POST TENDER ADDENDUM No. 02

Smithers Regional Airport
Terminal Upgrade and Expansion
Smithers, BC Contract 2017-11
July 21th, 2017 MW #16-181

STRUCTURAL POST TENDER ADDENDUM NO. 1

Revisions to Structural Drawings as Issued for Tender dated 2017/04/11:

LEVEL 1 FLOOR PLAN

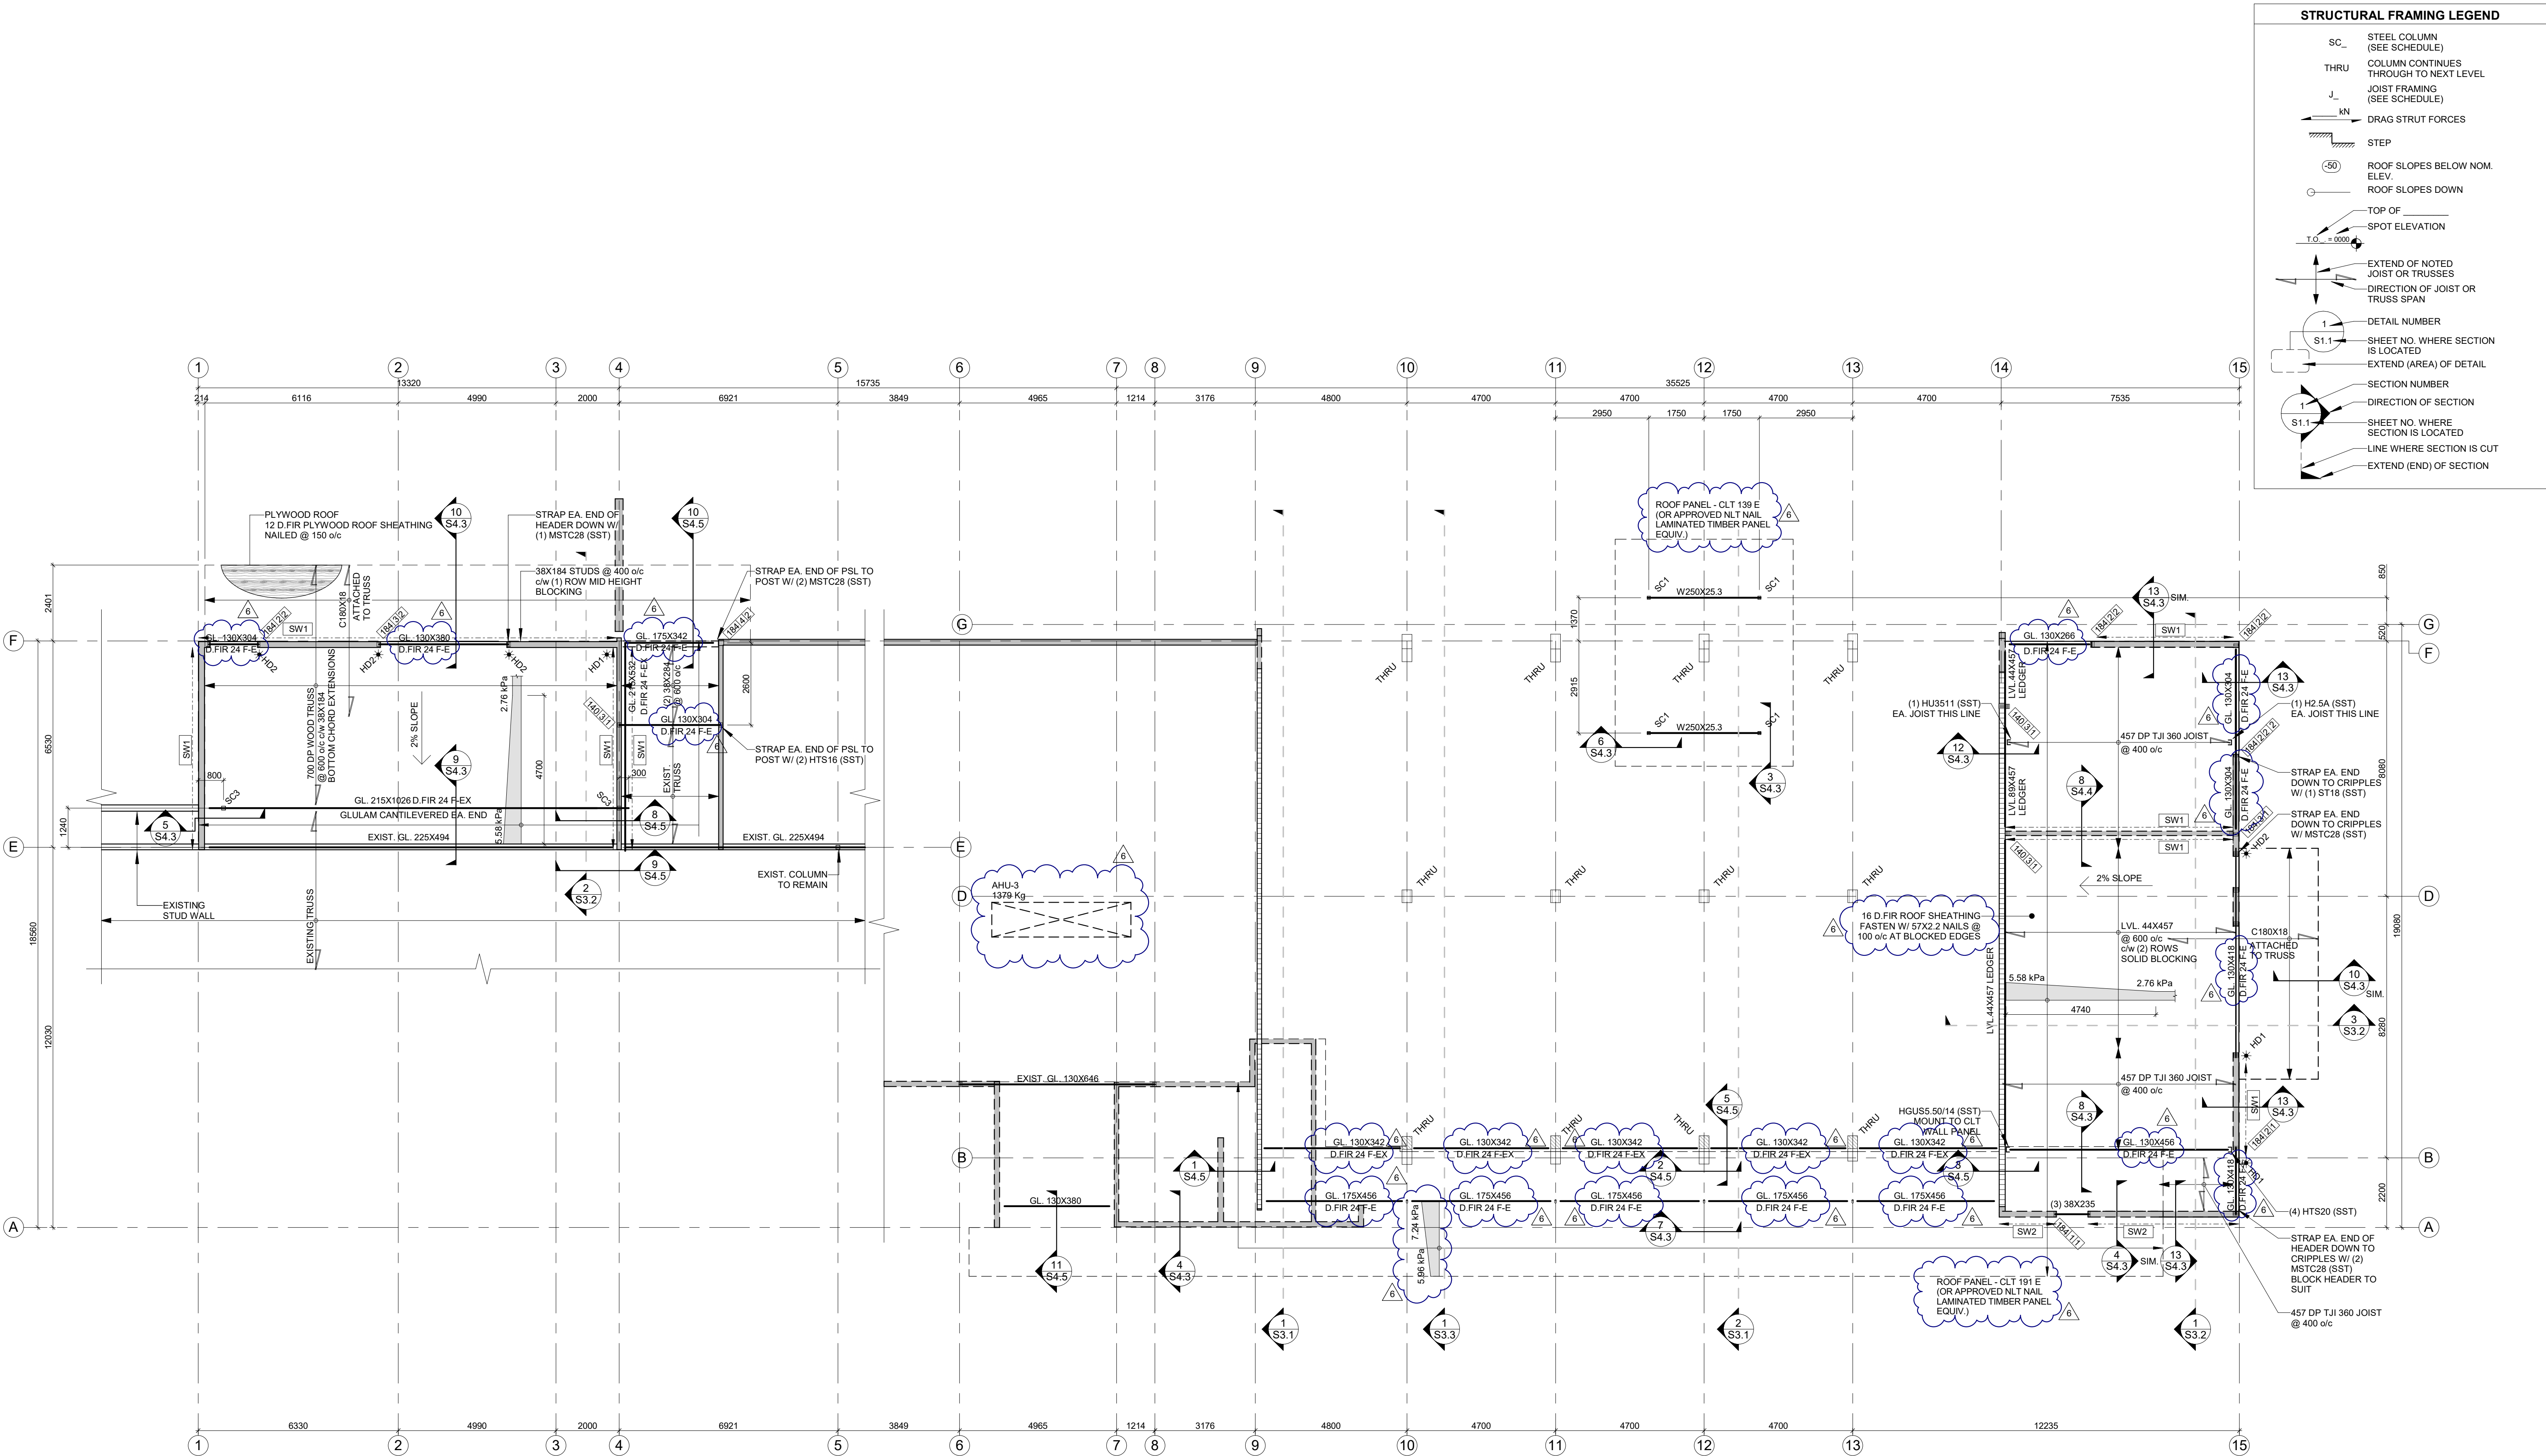
- 2. SHEET S2.2-1– LEVEL 1 FLOOR PLAN (VPG ITEM #SP2-2)**
 - i. Add** Level 1 Plan (1/S2.2-1)
 - ii. Add** Detail @ Door (2/S2.2-1)
 - iii. Add** Beam to Post Connection (3/S2.2-1)

1 HIGH ROOF FRAMING PLAN

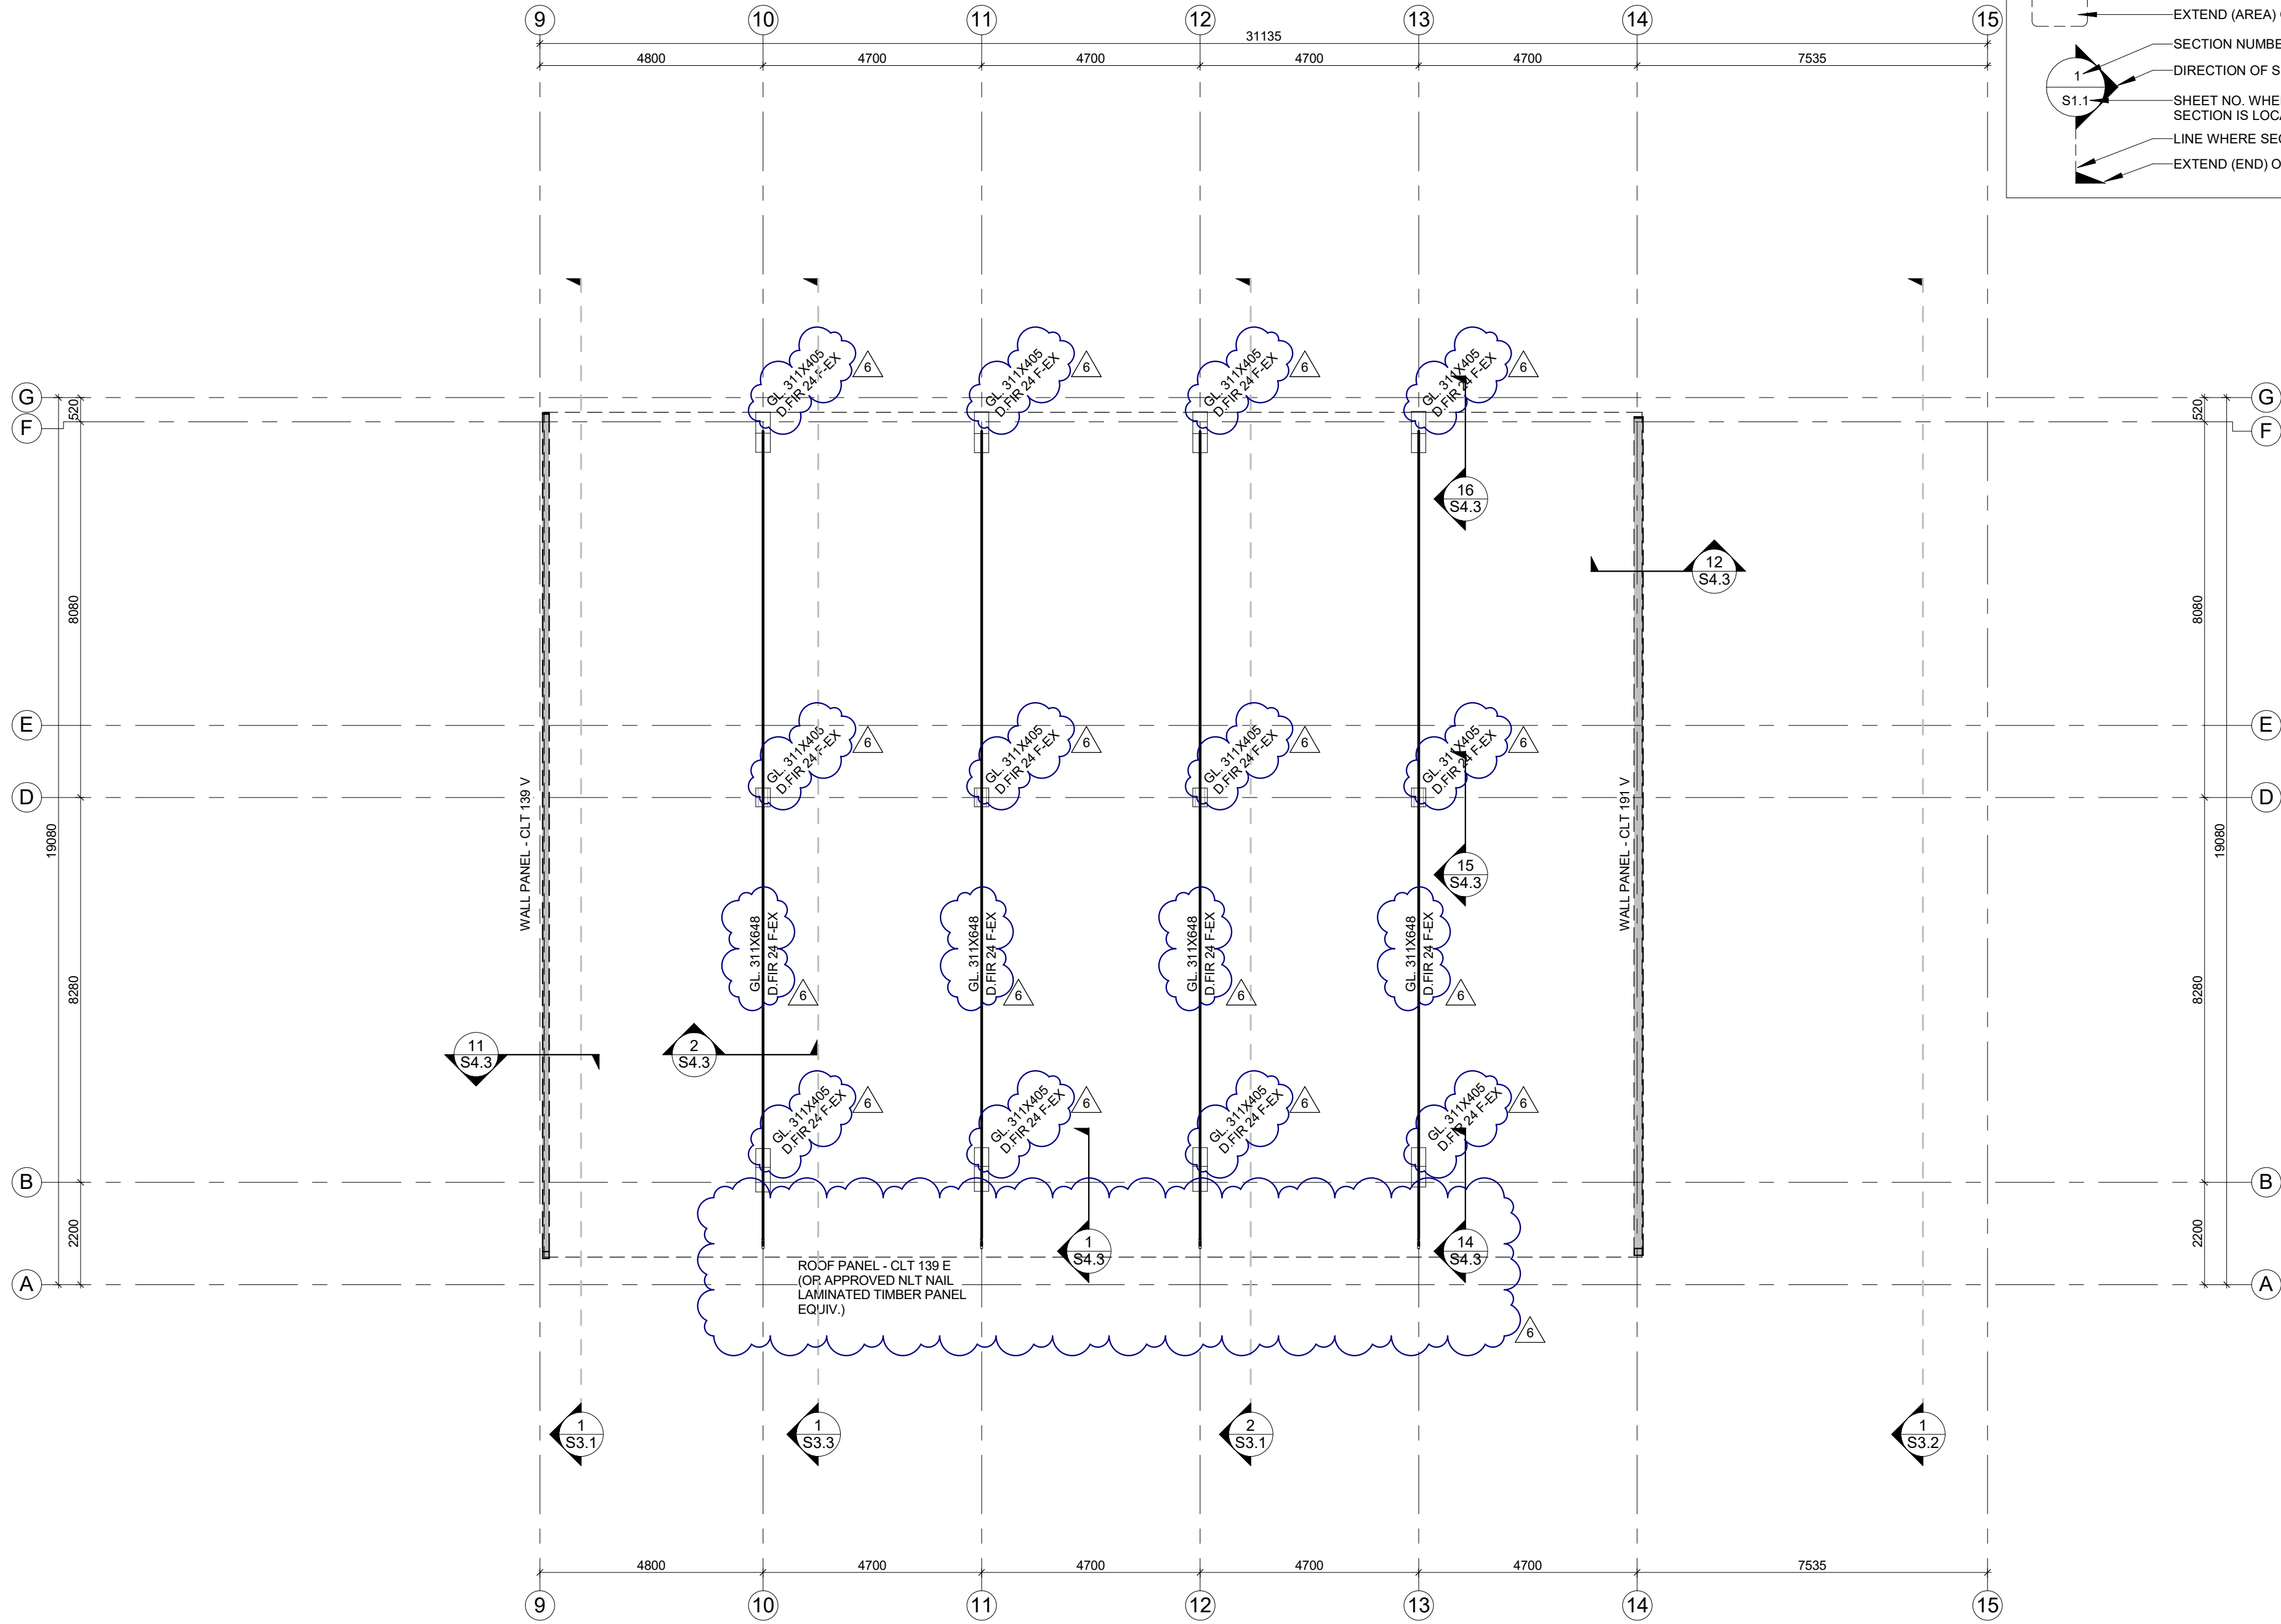
4. SHEET S2.4 – HIGH ROOF FRAMING PLAN (VPG ITEM #8 AND ITEM #16)

- i. Revise** all PSL beams to Glulam Beams
- ii. Revise** all PSL columns to Glulam Beams
- iii. Revise** Glulam column size
- iv. Revise** Glulam roof beam size and length
- v. Revise** NLT Roof panels can be used as an alternative for CLT Roof panels – submit alternative design to Kerkhoff Engineering for approval
